KOPPERS SITE
PRESENTATION TO USEPA
MEETING MINUTES
ATLANTA, GA
AUGUST 28, 2008

GRU Concerns Regarding Progress on the FS
for the Koppers Site
Presentation to USEPA August 28, 2008, Atlanta, GA

Modified from Figure 2, GeoTrans, Inc. April 2, 2008.
Response to Recommendation 6.

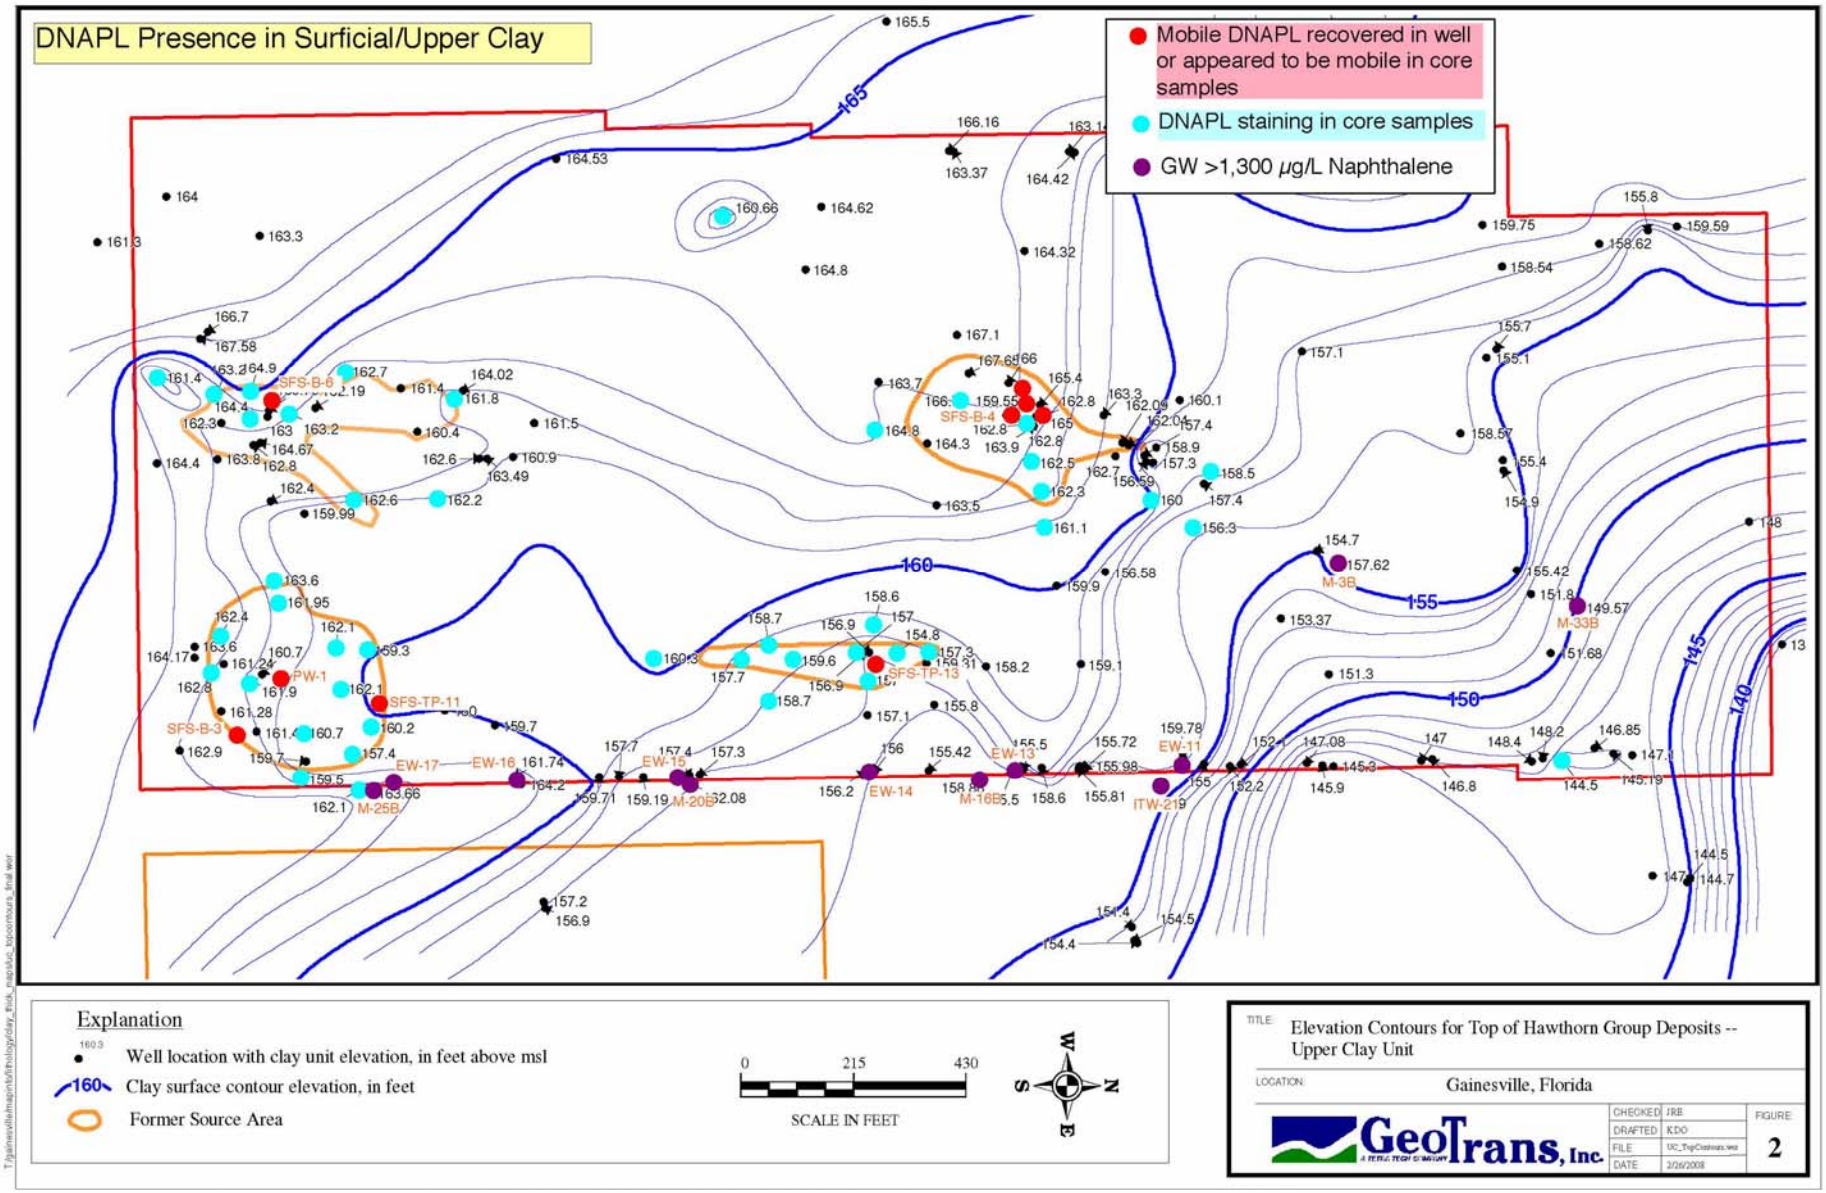
Potentially mobile DNAPL present
Source Zones larger than depicted by Beazer

Monitor Well ID: FW-6

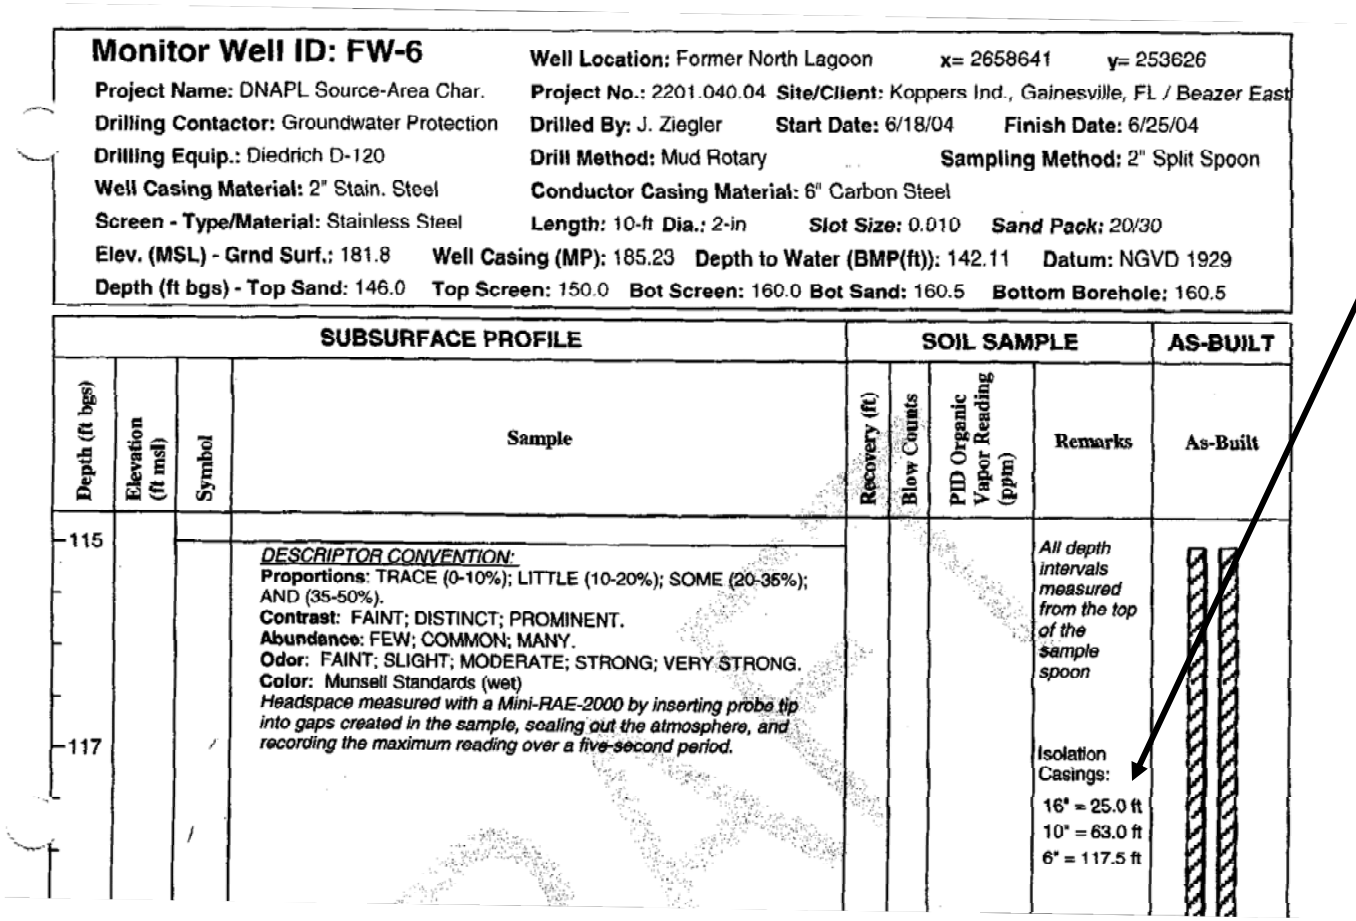
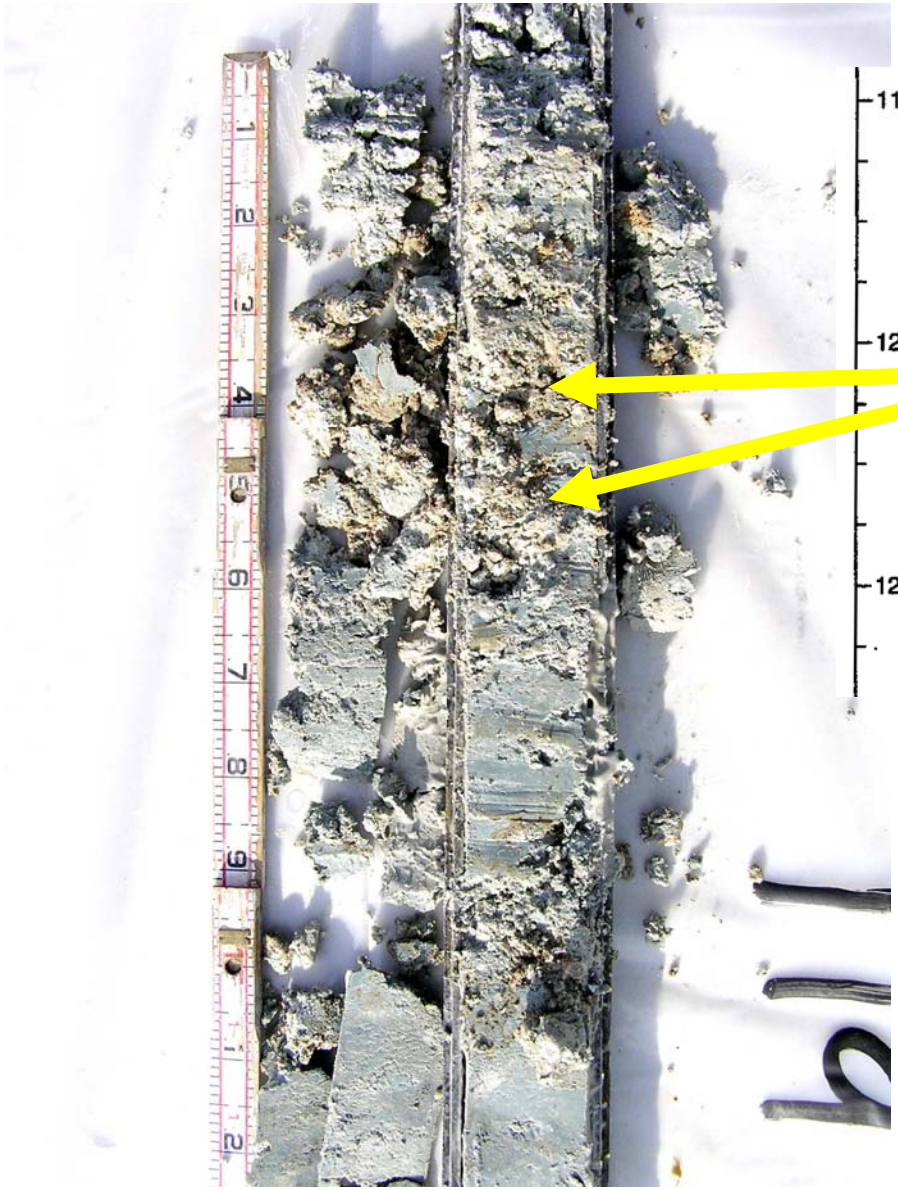
Creosote in FW-6 not likely caused by drag down:
